August 25, 2026

**Subject: RFQ #27022-A: Starrs Mill Educational Facility Building Modifications
Addendum #1**

Sketch

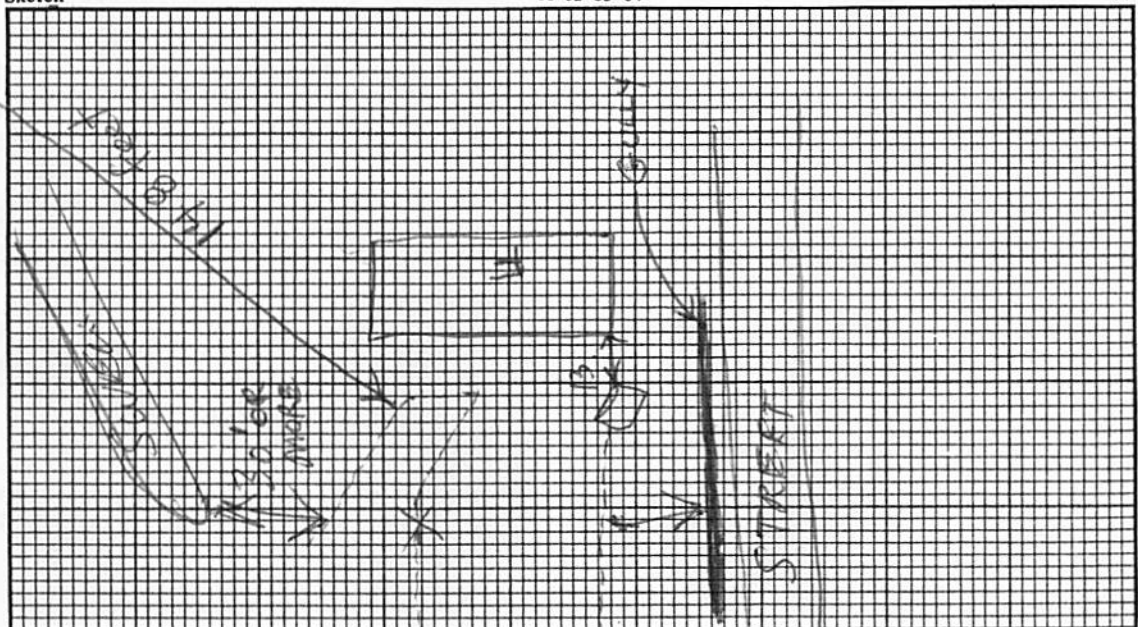
1. **The existing septic and drainfield is located near/within the current gravel parking area. The On-Site Sewage Management System Inspection Report is provided for reference (Attachment 1).**
